Peer Review of Hudson River PCBs Reassessment RI/FS Phase 2 Reports

Revised Baseline Modeling Report

**Hudson River PCBs Site Reassessment RI/FS
Baseline Modeling Report
Peer Review 3**

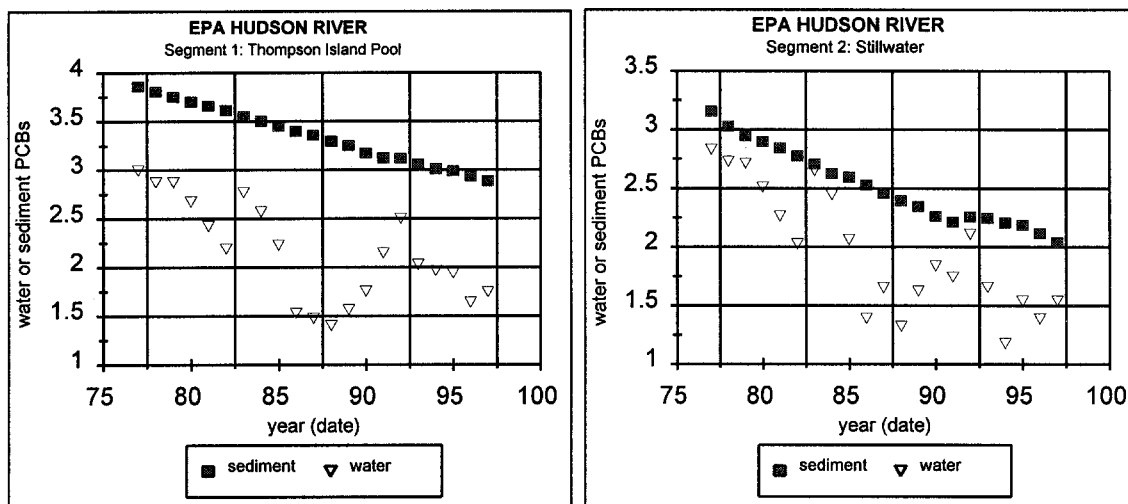
One such criticism is the employment of both variables, sediment and water, in a multiple regression for predicting fish PCBs because sediment and water concentrations are not independent of one another (an important assumption of multiple regression models). The response in the BMR considers that because of the nature of the river system, PCBs in water and sediments are not in equilibrium with one another, and hence it is justified to include both in a multiple regression (statistical procedures do not "care" about equilibrium). This is not a justification and is statistically invalid. This was also criticised in the Responsiveness summary (page 86/87); the response was the best fit (i.e. higher r^2) was obtained when both variables are included in the model. A scatter plot of sediment vs water concentrations was included suggesting

a weak relationship. However, examination of the data show strong site differences in both sediment and water concentrations, which must then be taken into account when examining the water to sediment PCB relationship. A plot of log-10 transformed water PCBs against sediment PCBs shows that 67% of the variability in water may be explained or related to sediment concentrations when differences among the 4 segments are taken into account using analysis-of-covariance (ANCOVA; see Figure 2 below).

Figure 2. Water concentrations are strongly related to sediment PCB concentrations on a log-10 transformed basis, based upon data used in the Bivariate BAF model ($r^2 = 0.67$). Note segment one is Thompson Island Pool (TIP).

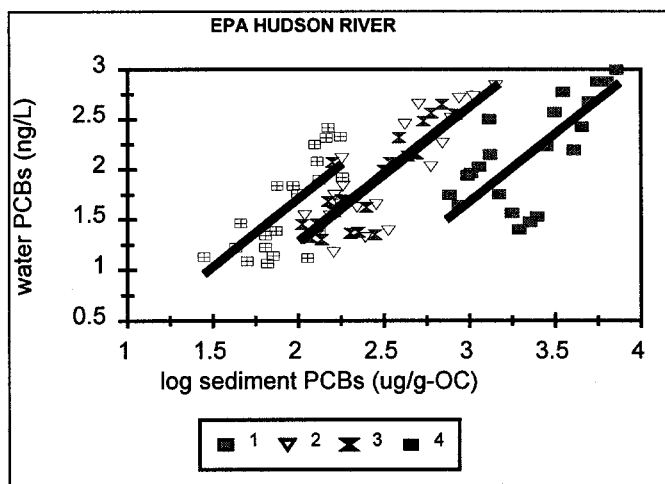
Using ANCOVA, there is found to be a significant difference in the relative concentration of water to sediment among the three of the 4 study segments of the river (segments 2 and 3 are similar). The ANCOVA results demonstrate that the slope is the same among the segments. (Note this may be an artefact of how the sediment concentrations are generated by the HUDTOX model, to decline at a similar rate relative to water concentrations among all reaches of the river over time; this needs to be examined.) Absolute concentrations are higher in TIP, but the intercept is lower, indicating a lower relative proportion of PCBs in water relative to sediment than downstream. If the reciprocal relationship is considered, this would mean that the ratio of the fugacities of PCBs in sediments relative to water are highest at TIP (actual ratio cannot be determined here because the water data are not expressed as freely dissolved PCBs normalized to organic carbon), similar in segments 2 and 3, and lowest at the reach below Federal Dam. A sediment to water fugacity ratio greater than one will indicate the net flux of PCBs will be out of the sediments into the water.

What these data clearly indicate is that sediment and water PCB concentrations are NOT INDEPENDENT of one another. It does not matter if the two media are not in equilibrium. There are several statements in the BMR which uses this latter point, and several others, to justify using these 2 variables together in a bivariate regression, but this is neither statistically nor logically valid, nor can the data be used to identify relative importance of sediment and water pathways to the biota. Also, as stated above, because the sediment data have no inherent variability in them, but the water data do, this also makes it impossible to establish the relative contribution of either media to biota PCB burdens. Nonetheless, as the following graphs will demonstrate, water and/or sediment are important driving factors behind biota PCB burdens and the relative importance of either may be less critical when concentrations are so high. Establishing water or sediment as the important source may be more important in a situation such as Lake Ontario, for example, where water concentrations are very low and a high sediment to water fugacity results in PCBs moving from sediments into the water column.

Figure 3. Lipid-normalized PCBs in three fish species in the first two river segments used in the

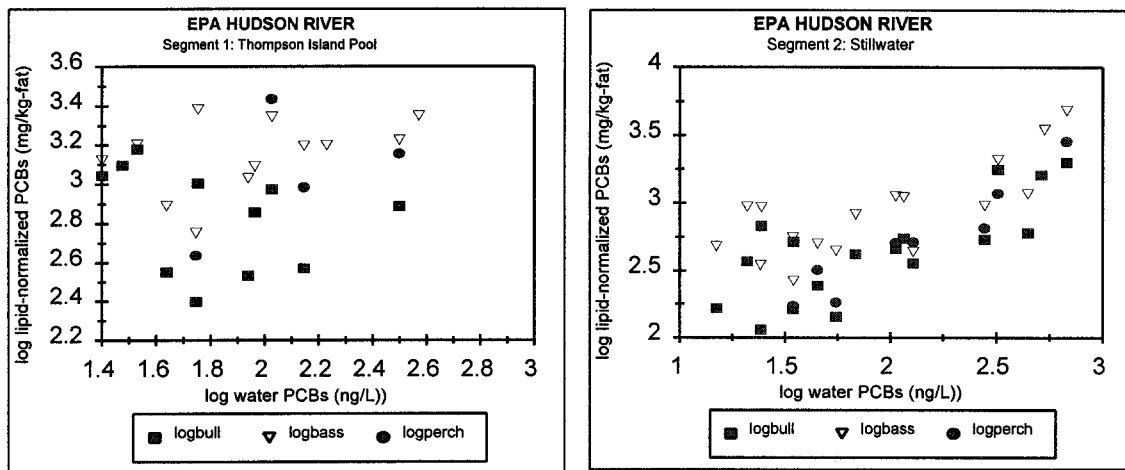
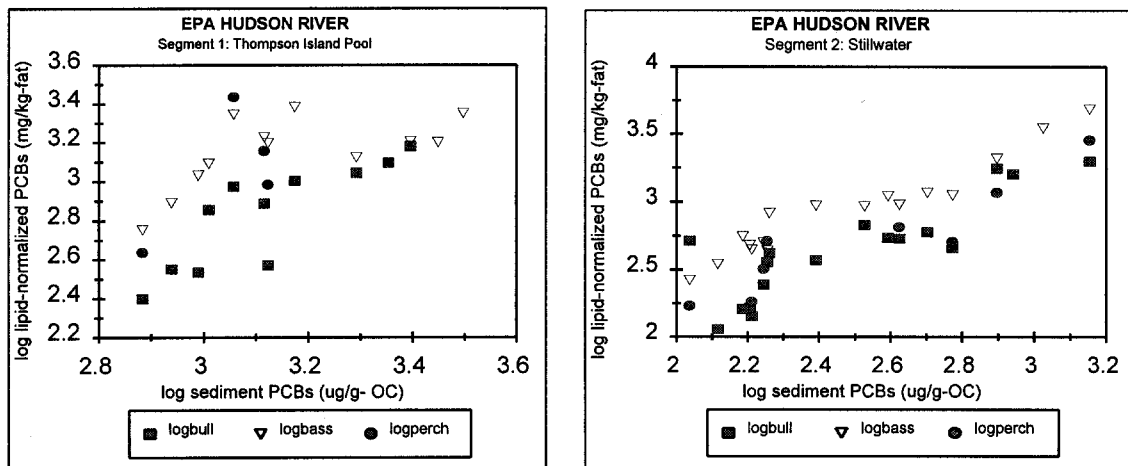
Next, the data should be considered in light of differences among the 3 segments in terms of water and sediment concentrations, and how these affect the relationships between the fish and the media PCB concentrations. This is done by ANCOVA, as shown in Figure 2 for the sediment and water data. The results are very interesting. Substantially more variability is explained in the fish PCB and water relationship when the River segment is taken into account for all three species. All regressions are highly significant. Note that in the BMR, page 54, section 4.2, the discussion pertaining to the single factor species-media regressions makes a weak, qualitative statement “despite increase in r^2 , the quality of fit remains weak”. This is rather subjective; comparing regression results uses more than just the r^2 , which pertains to degree of variance explained by the model. The probabilities must also be reported. As shown in the table above, the results are highly significant. But the strengths of these relationships cannot be used to justify relative contribution of either sediment or water to fish PCBs. For example, the ANCOVA r^2 for largemouth bass is 0.69 for water&segment compared to 0.88 for sediment&segment. Using the rationale of the BMR, this would suggest that sediment is more important as a source of PCBs to largemouth than water but the opposite would be true for yellow perch. This is trying to explain too much with these data. Note in the table above, significant probabilities for the ANCOVA interaction term are significant for brown bullhead with water&segment and yellow perch (and marginally largemouth) with sediment&segment, indicating that the slope of the fish-PCB to media relationship varies among segments. Analyses can be done to detect which segments are different (although this may be due to variable samples of fish in each segment, as for yellow

Relationships between fish lipid-normalized PCBs and water or sediment PCBs are shown for two segments.

Figure 5. Examples of relationships for lipid-normalized PCBs between pairs of Hudson River fish.

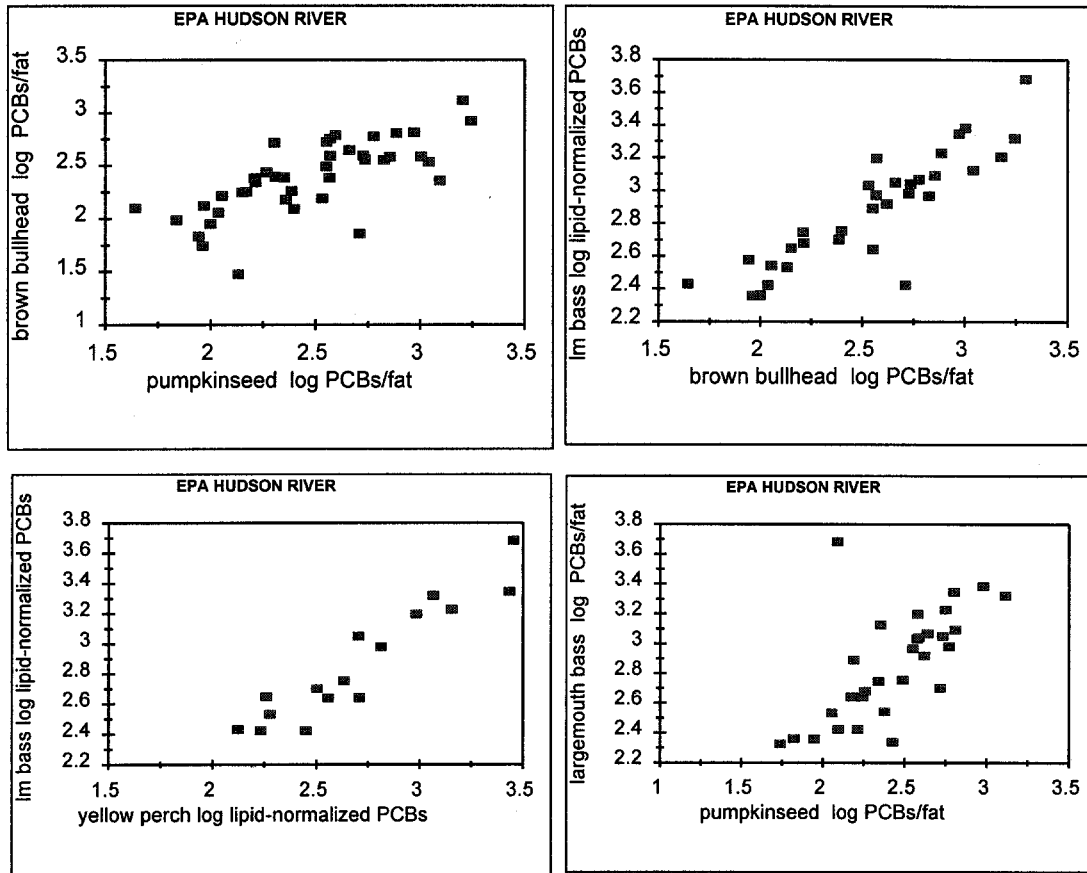
This is further illustrated by examining plots of lipid-normalized PCBs among pairs of biota. The relationships are very clear even between pairs of fish which are not closely related to one another in the trophic food web, such as brown bullhead and largemouth bass (Figure 5). Of the 4 fish pairs shown in Figure 5, these two had the least variable relationship with an $r^2 = 0.77$. This identifies that an external driving force operates on both species independent of food web structure. It is also useful to compare the BAFs derived here to literature values. This will be discussed under the probabilistic model.

$\log(\text{pumpkin}) = 0.29 + 0.96 (\log \text{ bullhead})$	$n = 32, r^2 = 0.69$
$\log(\text{lm bass}) = 1.08 + 0.71 (\log \text{ bullhead})$	$n = 33, r^2 = 0.77$
$\log(\text{lm bass}) = 0.92 + 0.72 (\log \text{ y perch})$	$n = 18, r^2 = 0.73$
$\log(\text{lm bass}) = 1.16 + 0.71 (\log \text{ pumpkin})$	$n = 30, r^2 = 0.66$
